CONDIT 66 K.V. REVISION
FROM POLE #1 TO #9

NORTHWESTERN ELECTRIC COMPANY,
PORTLAND, OREGON.

PNA-1981

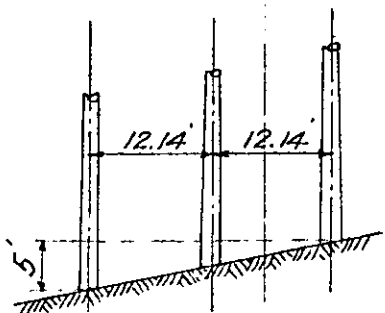
Replace #1 - (4 Pole Structure) with 3-Pole Structure

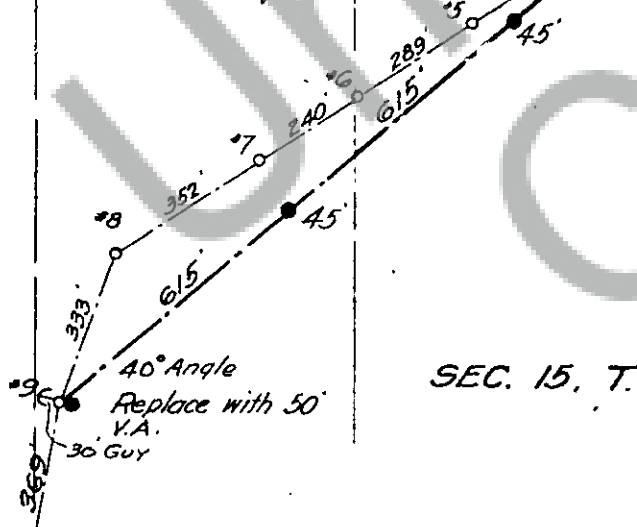
Replace #2 with 3-40 10' Centers

#3 - Replace with 2-40, 7' Centers (Stakes are set on 10' centers)
